MIDTOWN COLLECTION AT HANNAH RIDGE			
FILING NO. 1			
STREET IMPROVEMENT PLANS			
JAZZY LADY COURT / HORSEMANSHIP COURT			
DESIGNED BY	JRH	SCALE	DATE
DRAWN BY	JRH	(H) 1" = 50'	SHEET 7 OF 20
CHECKED BY	JRH	(V) 1" = 5'	JOB NO. 1116.30

**MIDTOWN COLLECTION AT HANNAH RIDGE**  
FILING NO. 1  
STREET IMPROVEMENT PLANS  
GRAND PRIX COURT

SF-19-007

PRIVATE STORM SEWER RUN 3 AND 4

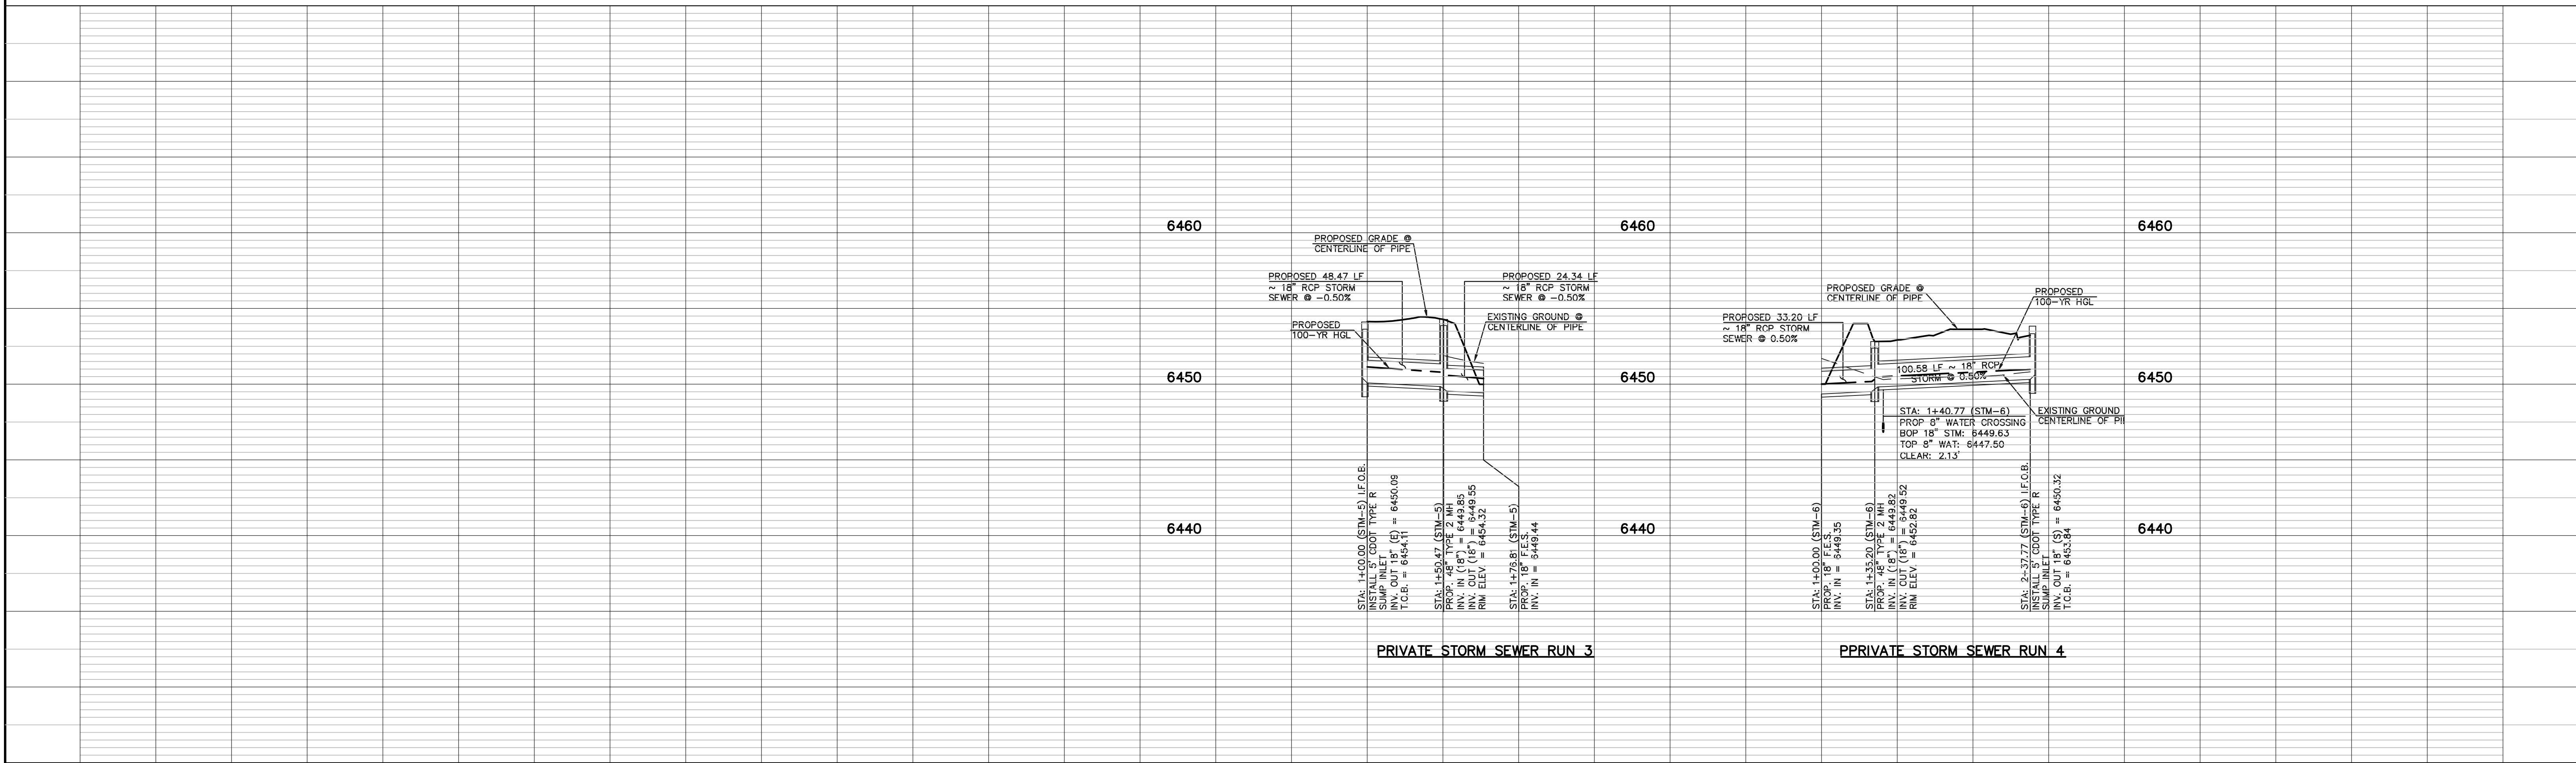
Include a note that indicates the sediment is removed from this facility prior to final acceptance

**4'X4' OUTLET BOX ORIFICE PLATE**  
SCALE 1" = 2"

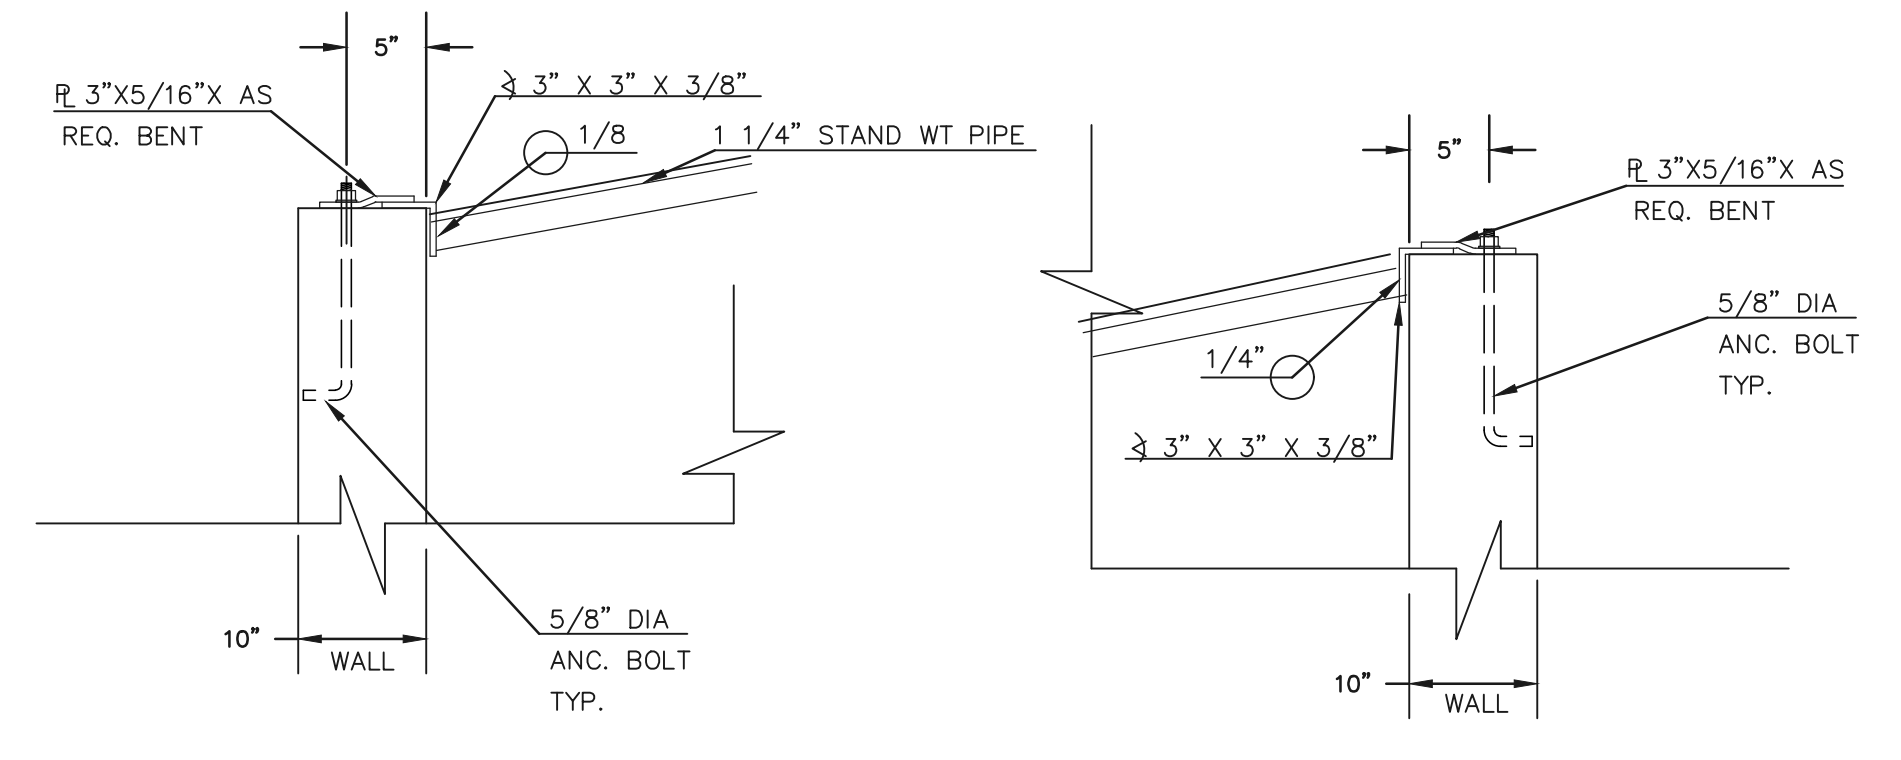
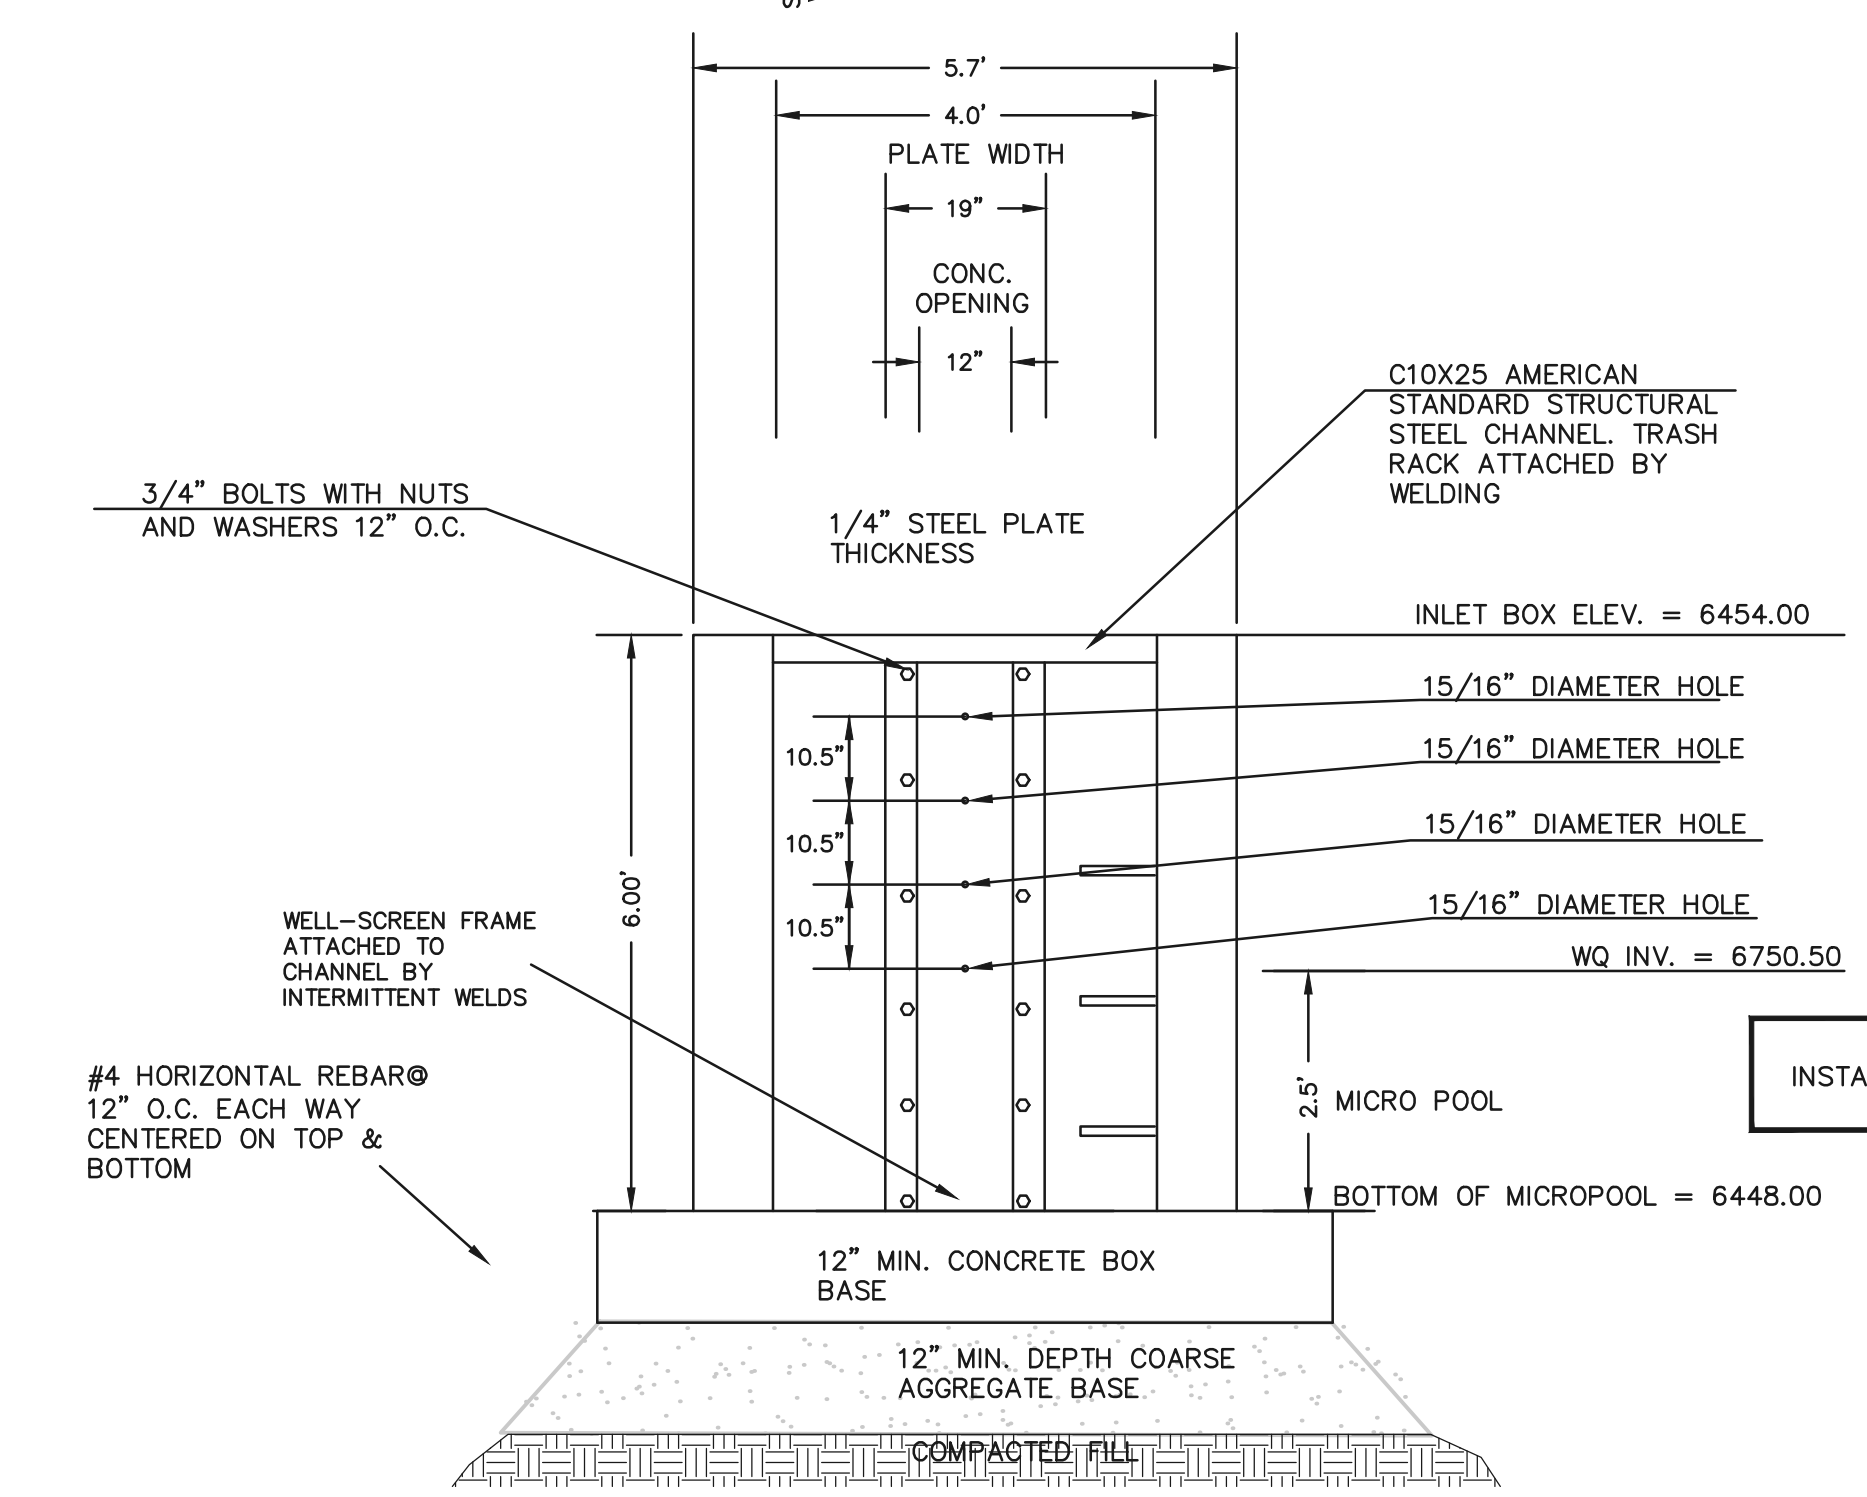
Call out the 100-Yr. WSE & the EURV. WSE
